APPLICATION FOR PERMIT TO DRILL OR REENTER

2. Name of Operator COG Operating LLC		7 If Unit or CA Agreement, Name and No. N/A
3a Address 550 W. Texas, Suite 100 Midland TX 79701		8. Lease Name and Well No. Empire Federal SWD #5
3b Phone No. (include area code) (432) 685-4384		9. API Well No. 30-015-39446
4 Location of Well (Report location clearly and in accordance with any State requirements.) At surface 850' FNL & 2310' FEL (UL B) At proposed prod zone		10. Field and Pool, or Exploratory SWD; Cisco
14 Distance in miles and direction from nearest town or post office* 4 miles South East of Loco Hills, NM		11 Sec, T R M. or Blk and Survey or Area Sec 10, T17S, R29E
15 Distance from proposed* location to nearest property or lease line, ft (Also to nearest drug unit line, if any) 850'	16. No. of acres in lease 1480	17 Spacing Unit dedicated to this well N/A
18 Distance from proposed location* to nearest well, drilling, completed, applied for, on this lease, ft 700'	19. Proposed Depth 9200'	20 BLM/BIA Bond No on file NMB000740

SWD WELL DRILLING PROGRAM

BOPE and Choke Schematic

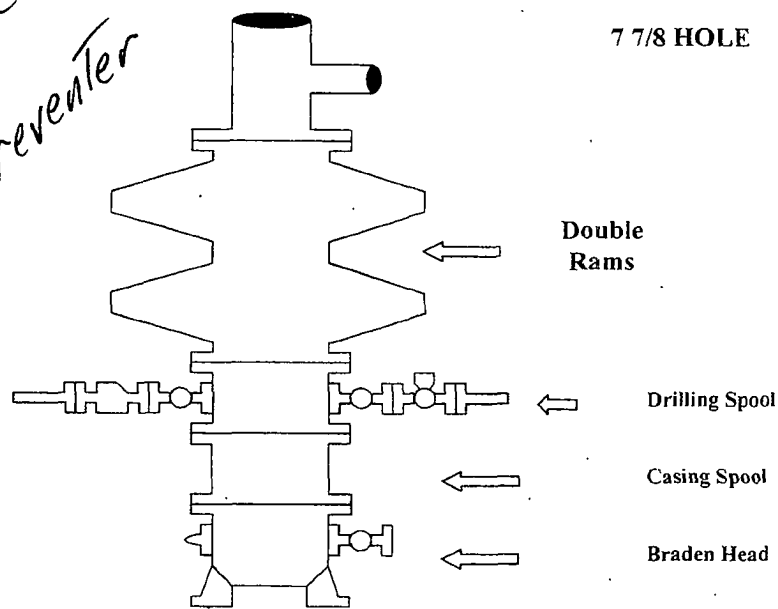
Must be A 3M system

*3 M System
With Annular preventer*

Minimum 4" Nominal choke and kill lines

Choke Manifold Requirement (2000 psi WP)
No Annular Required

3 M System
